PY-CEI/NRR-0072 L

Perry Nuclear Power Plant
Docket Nos. 50-440; 50-441
Response to NRC Question
Nos. 210.12 and 210.13 - Fast
Scram Hydrodynamic Loads on
the CRD System

FIGURE 1
SDV Piping

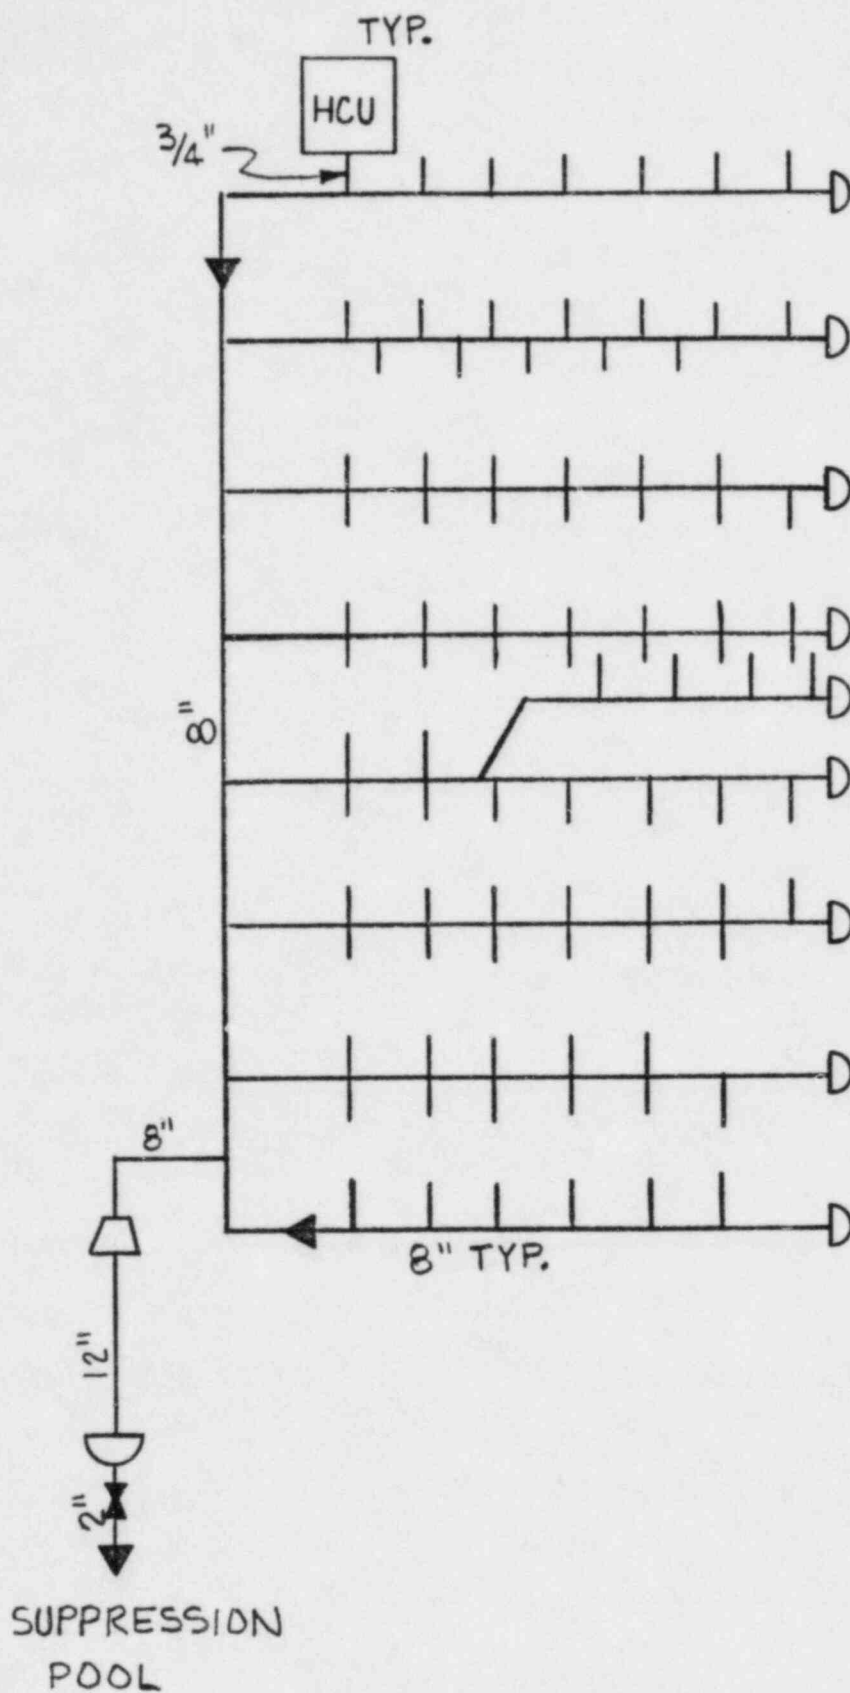
210.13 Provide an evaluation of the effect of the fast scram hydrodynamic loads on the integrity of the scram discharge volume (SDV) piping.

The evaluation of the effect of the fast scram hydrodynamic loads on the integrity of the SDV piping is provided below:

Each finger header (see Figure 1) contains approximately 14 connections through which the Hydraulic Control Units (HCU) discharge to the SDV. Each of these connections to the SDV is in the horizontal plane. Since the piping segments from the HCU to the SDV are very short, the net unbalanced hydrodynamic loads are small (approximately 20 pounds). These loads act in both the horizontal and the vertical directions.

In the horizontal plane, the load at each connection to the SDV tends to be balanced by the connections on the opposite side of the pipe. In the vertical plane, the loads are assumed to occur simultaneously and act in the same direction. The gross load on the SDV finger header would be $20 \times 14 = 280$ pounds. This load is distributed over a 12 foot span and can be considered to act as a uniformly distributed load of 23.3 lb./ft. The dead weight of this piping is approximately 100 lb./ft. and produces a stress of 1000 psi, which is considered to be very small compared to the normal allowable stresses used in design. The effect of the 23.3 lb./ft. is, therefore, considered to be negligible. The symmetrical layout of this system as well as the supporting arrangement is such that the design requirements are not exceeded when the hydrodynamic loads are applied.
